Landscape Review Committee Community Development Center, 231 NE 5th Street January 15, 2020 12:00 PM

DATE:January 15, 2020TO:Landscape Review Committee MembersFROM:Jamie Fleckenstein, Associate PlannerSUBJECT:Agenda Item 4B – Landscape Plan Review Application (L 29-19)

DECISION, CONDITIONS, FINDINGS OF FACT AND CONCLUSIONARY FINDINGS FOR THE APPROVAL OF A LANDSCAPE PLAN REVIEW AT 2730 NE DORAN DRIVE

DOCKET:	L 29-19 (Landscape Plan)
REQUEST:	Approval of a Landscape Plan for A Multi-Family Apartment Building
LOCATION:	2730 NE Doran Drive (Tax Lot 1803, Section 10C, T. 4. S., R. 4 W., W.M.)
ZONING:	C-3PD (General Commercial Planned Development)
APPLICANT:	Premier Home Builders, Inc., property owner
STAFF:	Jamie Fleckenstein, PLA, Associate Planner
DATE DEEMED COMPLETE:	December 16, 2019
HEARINGS BODY & ACTION:	McMinnville Landscape Review Committee makes a recommendation of approval or denial to the Planning Director.
HEARING DATE & LOCATION:	January 15, 2020, Community Development Center, 231 NE 5 th Street, McMinnville, Oregon
PROCEDURE:	Landscape plans are required to be reviewed and approved by the Landscape Review Committee as described in Section 17.57.050 (Plans-Submittal an

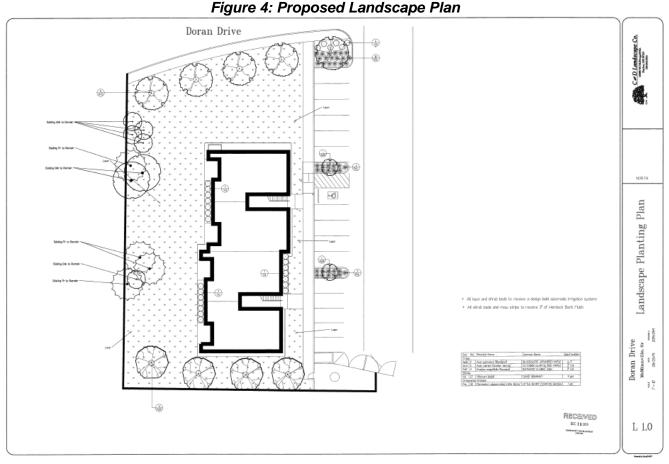
Acer rubrum 'October Glory' (October Glory Red Maple) trees are proposed along the northern property line, spaced at approximately 25 feet on center. This variety grows approximately 40 feet tall and 35 feet wide, and would provide continuous canopy along the street frontage at the proposed spacing at maturity. The line of trees extends to the shared driveway between the proposed apartment building and the adjacent memory care facility. The easternmost tree is outside of the required vision clearance triangle for multi-family and commercial driveways, however, the geometry of Doran Drive is such that a tree in this location may impact sight distances from vehicles exiting the site. Staff recommends a condition of approval to remove the easternmost *Acer rubrum 'October Glory'* to maintain clear sight distances to the west on Doran Drive.

Between the proposed apartment building and the adjacent Wilco Farm Store property to the south is a 20 foot wide sewer easement where landscaping is proposed. Four (4) *Fraxinus angustifolia 'Raywood'* (Raywood Ash) are proposed at approximately 25 feet on center. Raywood Ash grow to approximately 55 feet tall and 30 feet wide. These trees will provide shade and cooling benefits to the building, as well as screen the adjacent use on the Wilco property, which is outdoor storage. The south side of the building has limited windows and views from the apartment units, so the continuous canopy provided by the trees will provide screening of the outdoor storage area. Located at the end of the shared driveway is a trash and recycling enclosure that will be shared by the apartments and memory care facility. No landscaping is proposed immediately adjacent to the enclosure. This is addressed in more detail below.

CONDITIONS FOR FINDING: That the easternmost *Acer rubrum 'October Glory'* (October Glory Red Maple) along the northern property line be removed to maintain clear sight distances to the west on Doran Drive.

CONDITION FOR APPROVAL: That sight-obscuring planting be provided along the southern property line to screen the adjacent commercial outdoor storage area.

CONDITION FOR FINDING: That landscaping be provided around two (2) additional sides of the trash and recycling enclosure, including within the adjacent parking lot island and next to the pedestrian gate access. Plant material must be a minimum of three (3) feet in height at the time of planting.

Figure 9: Apartment Building Perimeter Landscaping

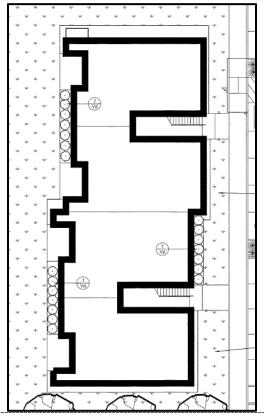
The perimeter of the apartment building is surrounded by a landscape bed, ranging in width from approximately one (1) foot to four (4) feet. In the wider areas on the east and west sides of the building, David Viburnum is planting in a continuous row. No planting is proposed for the wider bed on the north side of the building visible from the public right-of-way. The narrow beds without planting are intended to be mow strips to ease maintenance around the building. Staff recommends a condition of approval to provide planting along the north side of the building, where the proposed landscape bed is wide enough to accommodate planting and it is visible from the public right-of-way.

That landscaping be provided along the north side of the proposed apartment building consistent with other building perimeter landscaping.

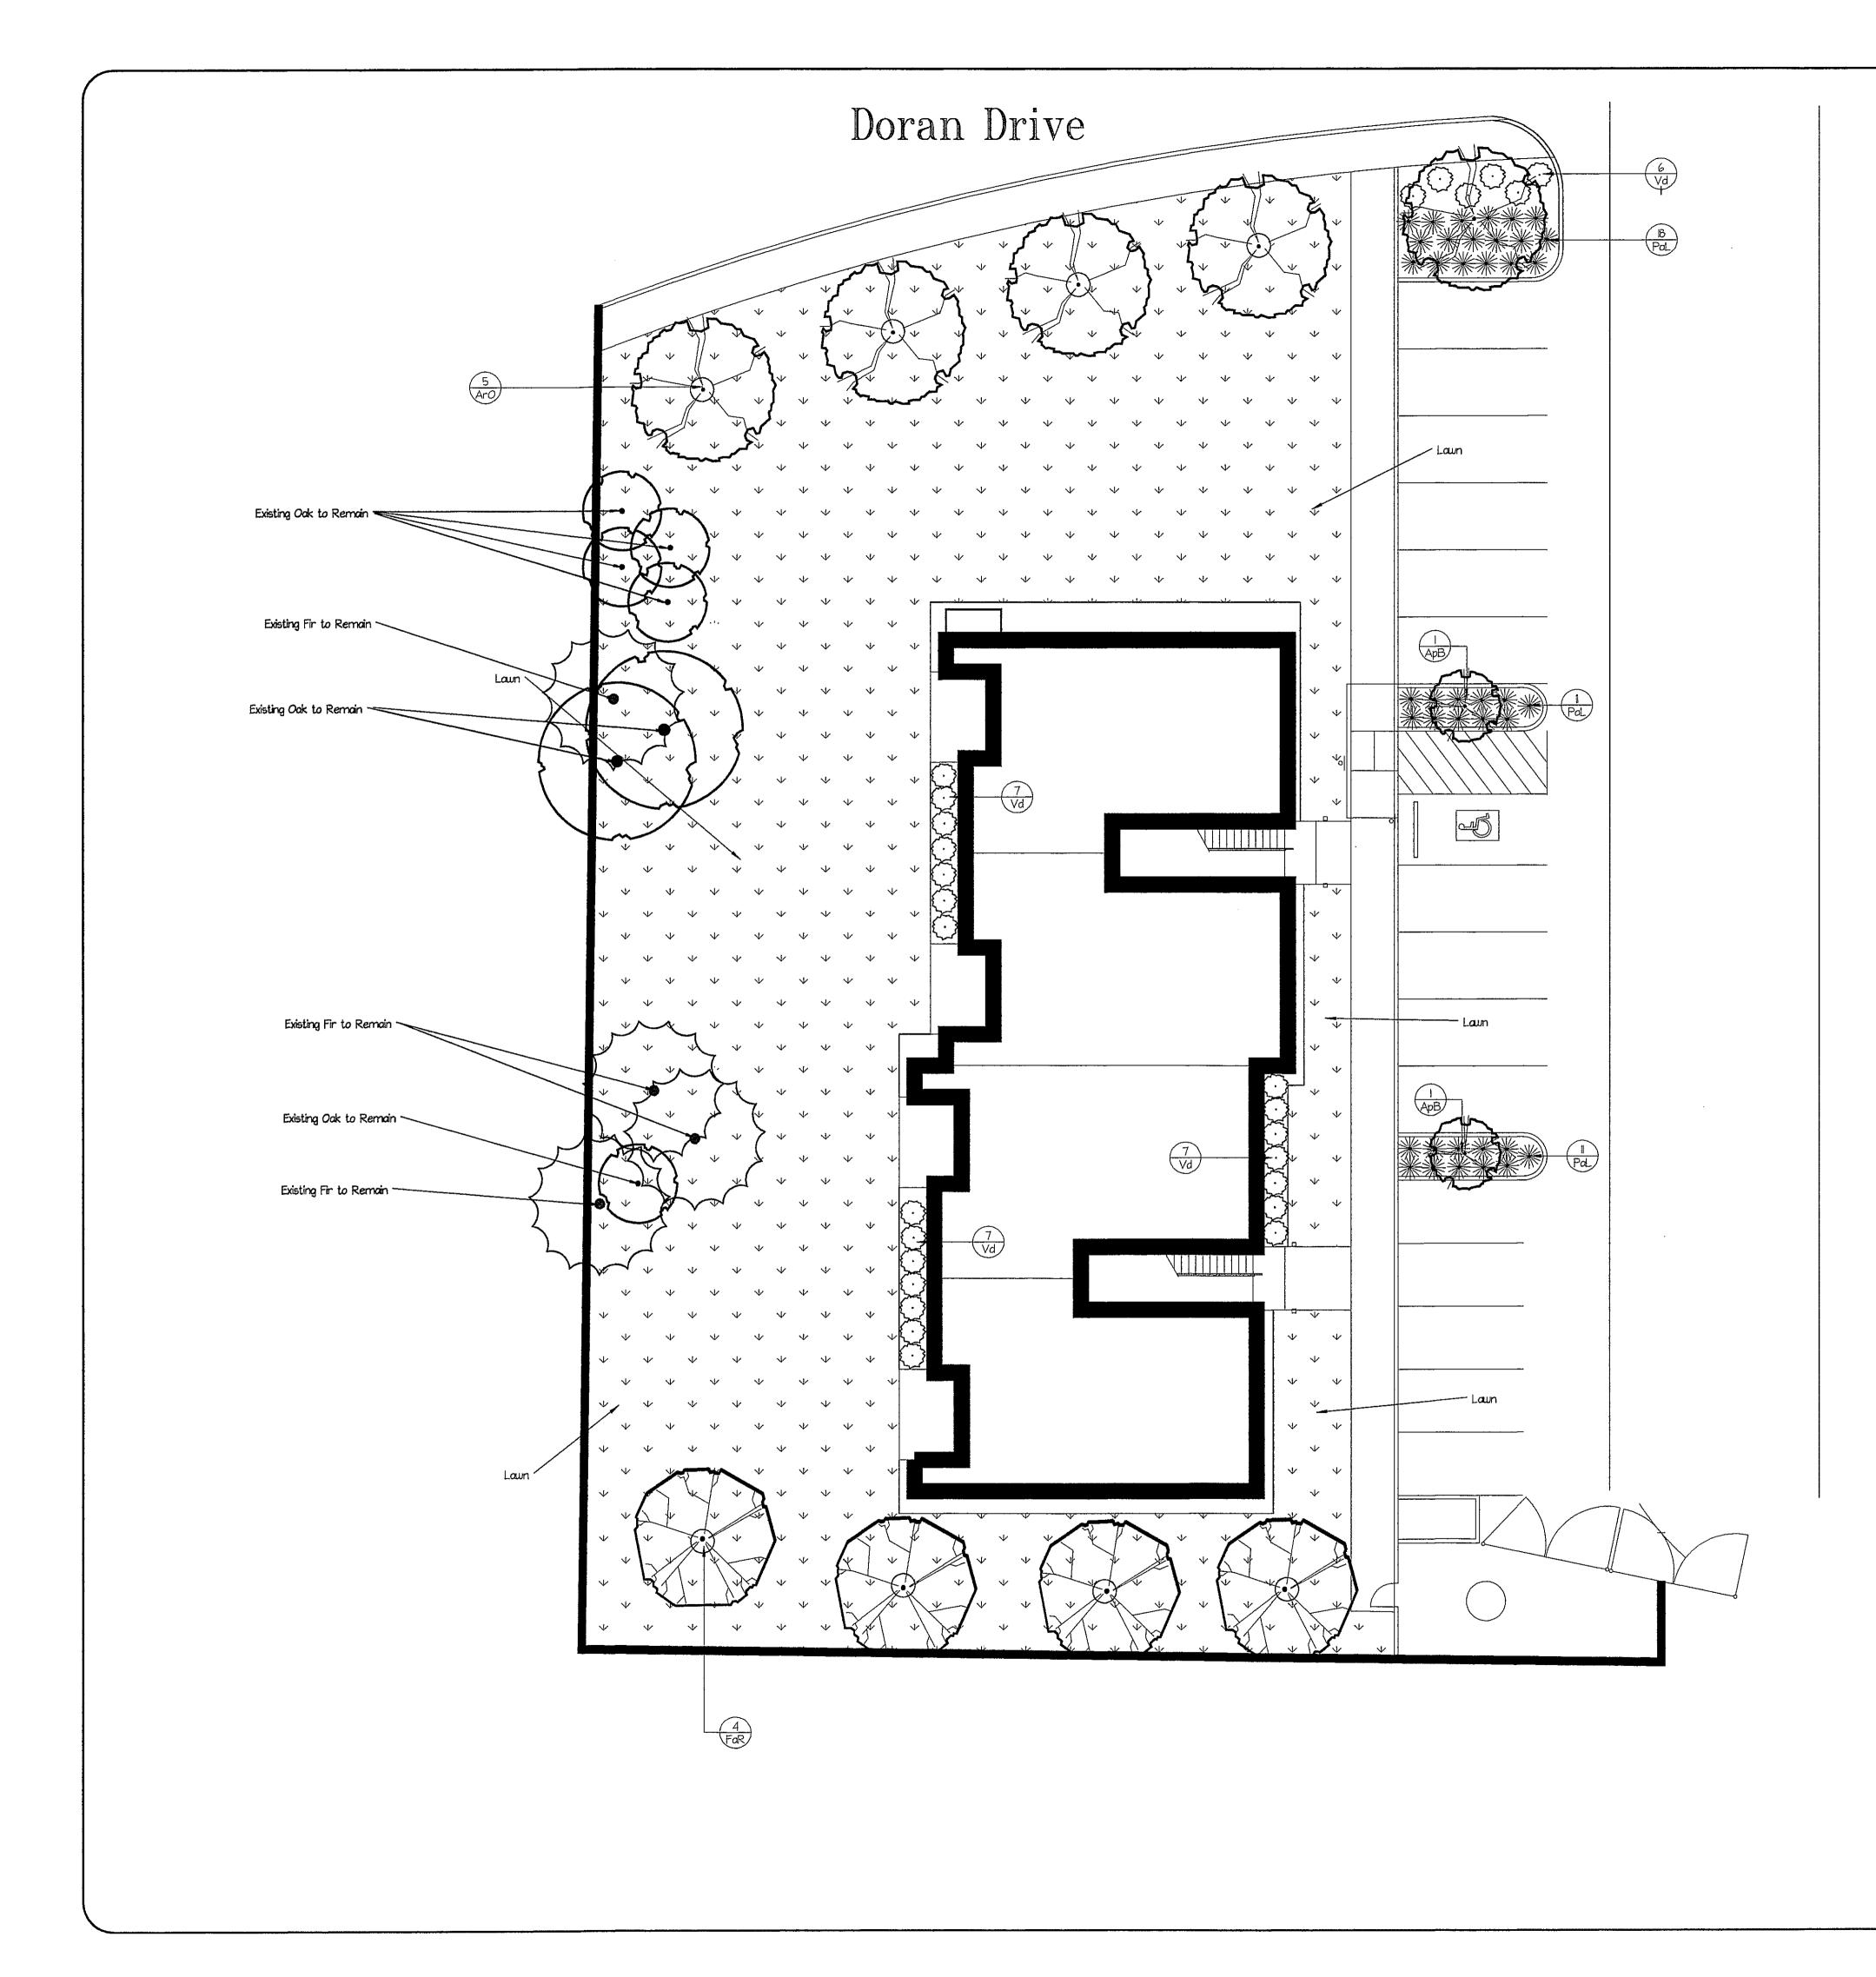
Proposed trees on the north property line must maintain minimum clearances from existing street lighting. Those minimum clearances include mature tree canopy. Beyond that we are unable to review or approve plans until power system design is completed and electrical extension agreement signed.

MW&L cannot approve the landscape plans until the public water system design has been approved by MW&L.

- 1. The submitted landscaping plan appears to show trees planted outside of the public right of way behind the sidewalk. It shows October Glory red maple. This is a proven street tree choice that is on the City's recommended street tree list. October Glory will potentially grow to a mature height of 40' with a spread of 35'.
- 2. The submitted plan shows the trees being planted in an irrigated turf stand.
- 3. The remainder of the proposed landscaping improvements appear to be outside of the public right of way, and thus outside of our purview.

- b. Within 20' of street light standards or street intersections
 - c. Within 5' of a private driveway (note: given the geometry of the adjacent roadway which will impact the sight distance for vehicles exiting the property, the applicant should consider not planting the easterly tree to reduce impacts on sight distance.)

- 1. That the applicant shall install landscaping as shown on the landscape plan submitted to the Planning Department on December 13, 2019.
- 2. That the easternmost *Acer rubrum 'October Glory'* (October Glory Red Maple) along the northern property line be removed to maintain clear sight distances to the west on Doran Drive.

- 3. That landscaping be provided along the north side of the proposed apartment building consistent with other building perimeter landscaping.
- 4. That sight-obscuring planting be provided along the southern property line to screen the adjacent commercial outdoor storage area.

- 5. That the applicant is reminded that any tree planted partially or wholly within the right-of-way is considered a street tree, and shall be planted per the City's approved street tree standards, including the provision of root barrier protection placed in 10 foot lengths against the sidewalk, centered on the tree and to a depth of 18 inches; and that street trees are not to be planted within five (5) feet of a private driveway or alley; ten (10) feet of a fire hydrant, transformer, power or water vault, water meter box, utility pole, sanitary sewer, storm or water line; twenty (20) feet of street light standards or street intersections.

- 6. That landscaping be provided around two (2) additional sides of the trash and recycling enclosure, including within the adjacent parking lot island and next to the pedestrian gate access. Plant material must be a minimum of three (3) feet in height at the time of planting.

- 7. That the applicant shall maintain proper clearances around the existing and future water and electrical services that will be located on the site. Landscaping shall not be placed within four (4) feet of fire hydrants, within four (4) feet of water valves, within four (4) feet of vaults, within three (3) feet of the back or side of a transformer, or within one (1) foot of water meters. Minor adjustments in plant placement from the locations shown on the approved landscape plan are allowed if relocation is necessary to meet minimum clearances.
